ADDENDUM NO. 3
COUNCIL BLUFFS COMMUNITY SCHOOL DISTRICT
Abraham Lincoln High School &
Thomas Jefferson High School CTE Remodel (Phase 2)
Council Bluffs, Iowa

HGM PROJECT #140218

DATE OF ISSUE: January 10, 2019

CTE REMODEL THOMAS
JEFFERSON HIGH SCHOOL
TJHS-ENLARGED MECHANICAL PLAN

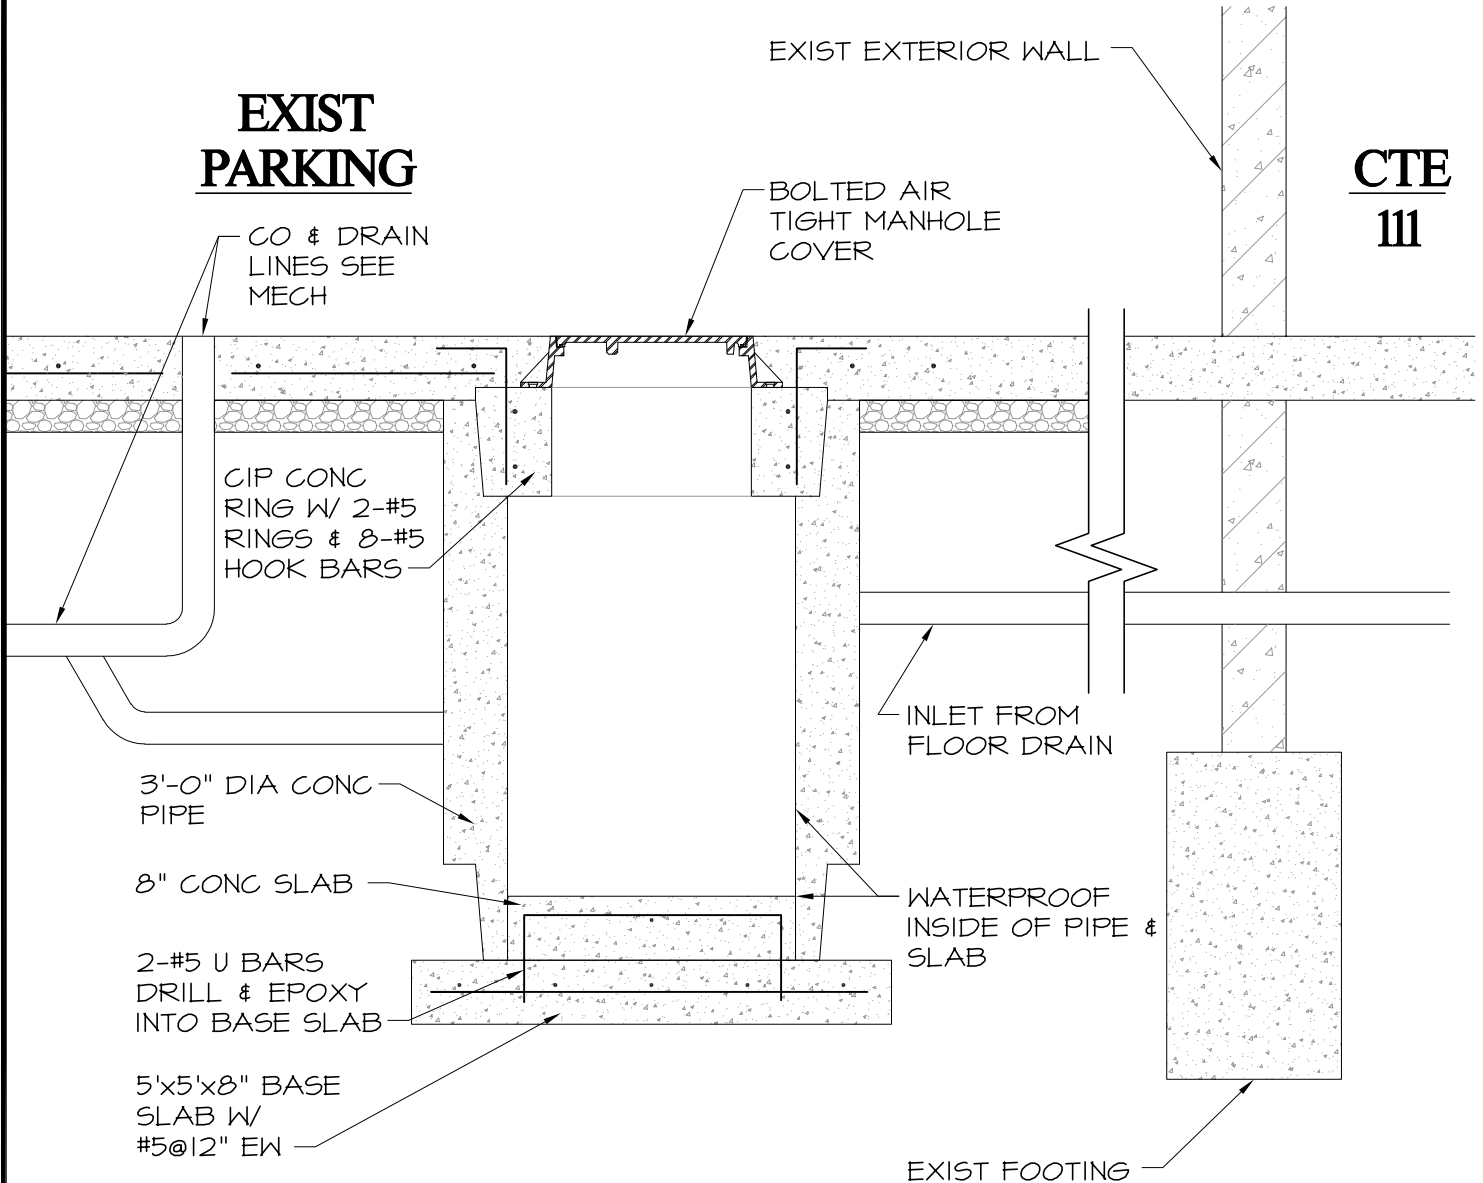
15 A. Install a diffuser in the new ceiling above Virtual Welding 109 as shown. See attachment 1M.

OIL SEPARATOR

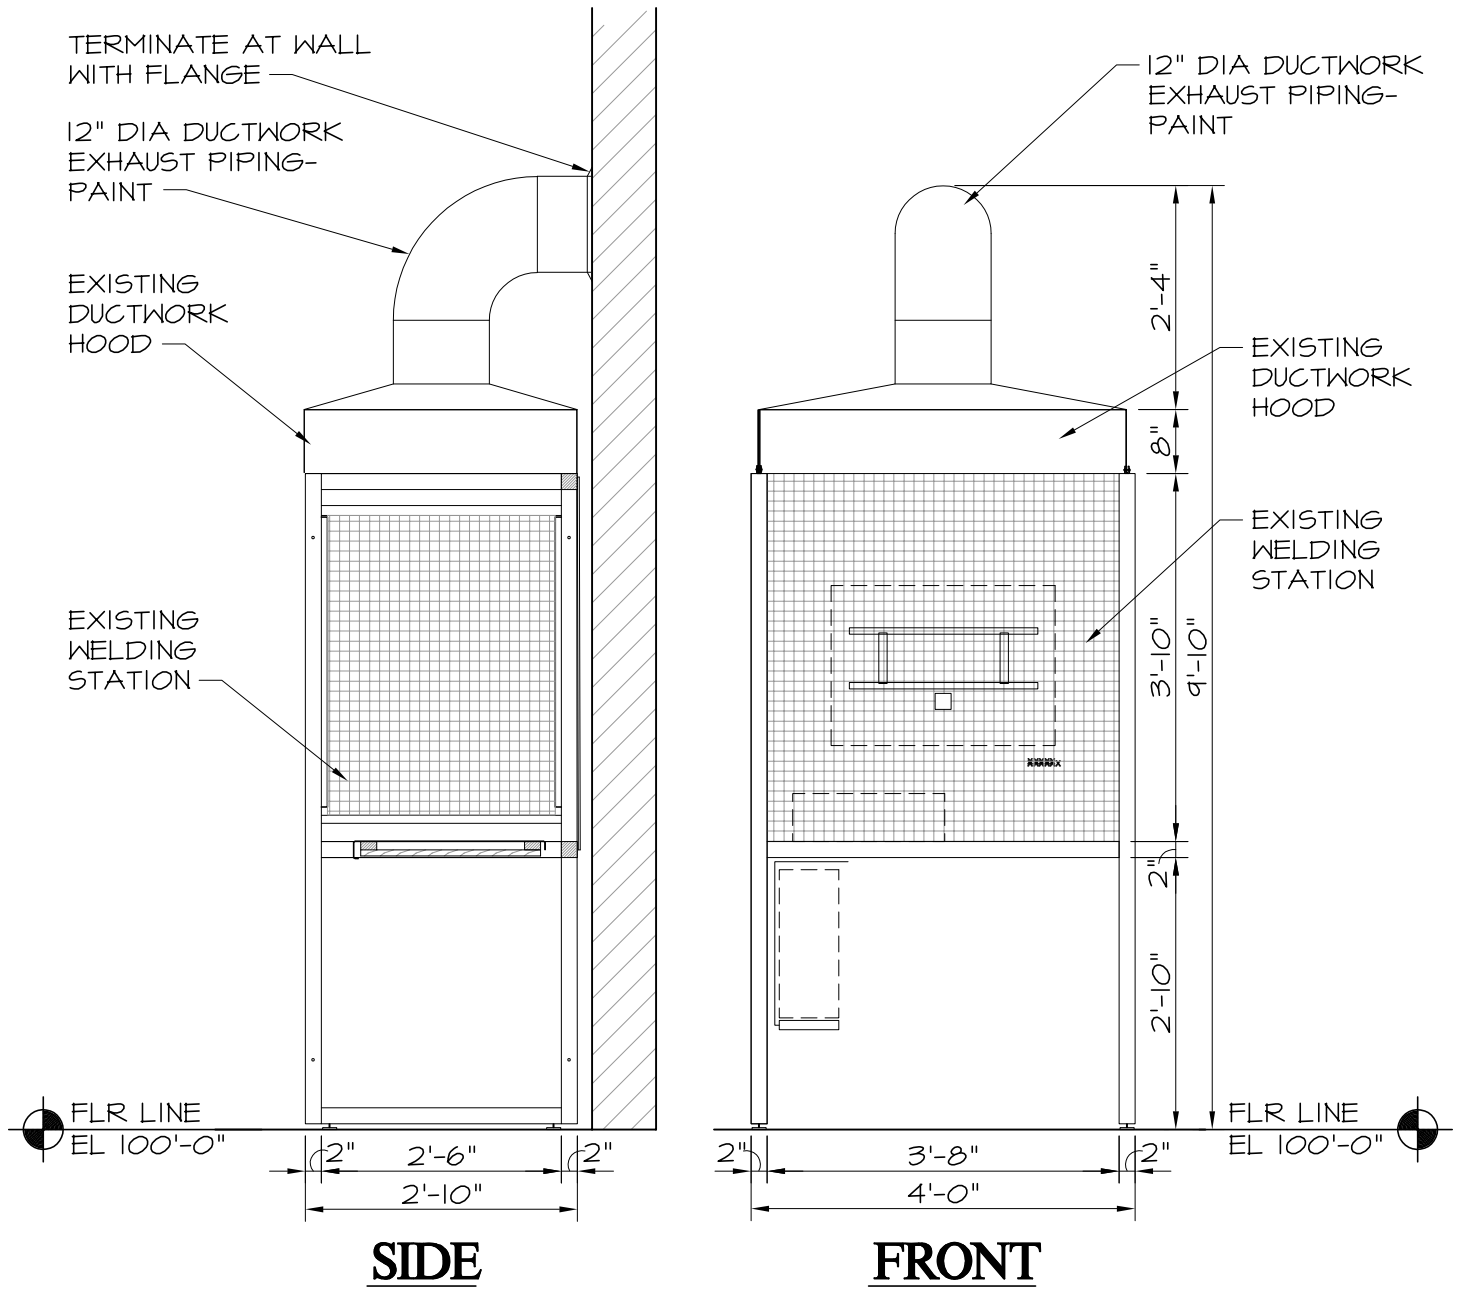
31
32 Refer to Oil Interceptor; Add the following:

33 Refer to attached detail SD1. Refer to SUDAS specifications for manhole cover requirements.

DEPTH OF OIL SEPARATOR SHALL BE COORDINATED BY CONTRACTOR BASED ON DEPTH OF EXIST SEWER LINE. REFER TO AND COORDINATE WITH MECHANICAL DETAIL 3/M3.1
